CSB-1013-2
 Country : UK
 Date : 2/2/2007
 APC : ALL
 Repair Level : 2

Title C168/C168i/W220 - GSM - No Vibrate
 Model Effected C168,C168i,W220

Deformed Armature

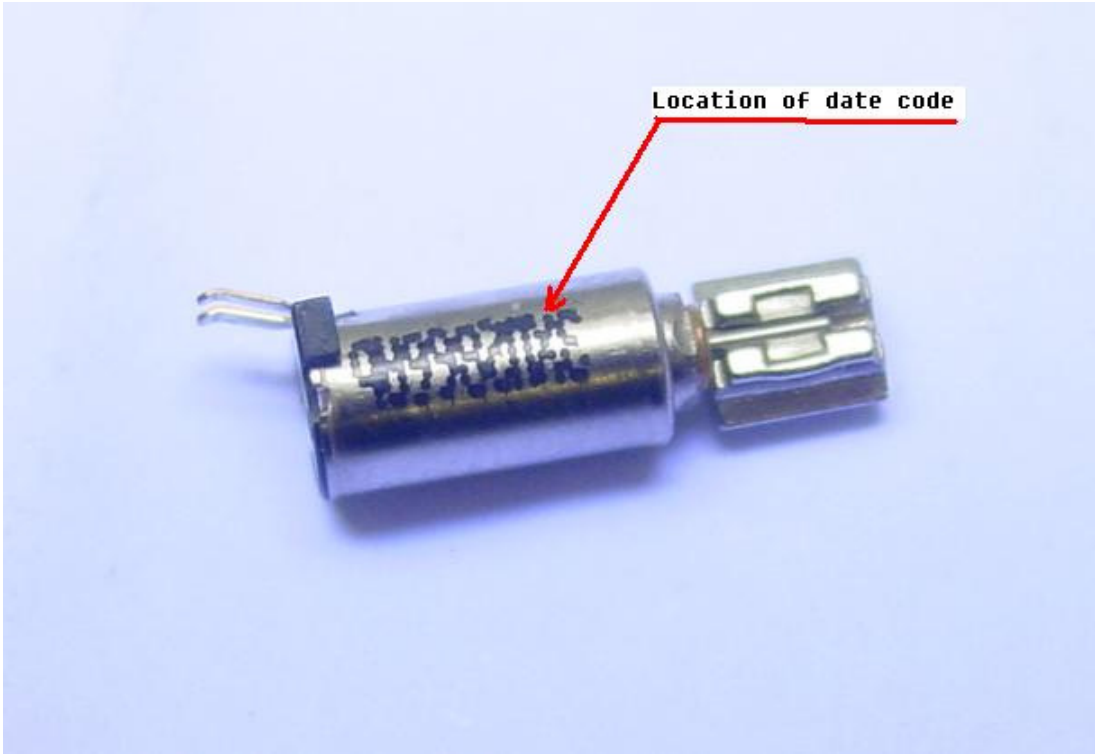
An issue was found in the C168/W220 MOL analysis process. The customer complained: "No vibrate". The root cause is vibrator can not work normal. The analysis revealed the Armature Deformed of vibrator. Vendor Panasonic is analyzing the cause of Armature Deformed.

Armature deformation is due to the tape around the armature shrinkage. Action is to change the new tape from Jan 03, 2007. New vibrator date code is Jan/03'07 and with the mark of "Ba". For example, 3XU0317Ba.

When C168/C168i/W220 handsets returned to service center with the customer complaint of 'No vibrate', Please replace a new vibrator with the new data code.
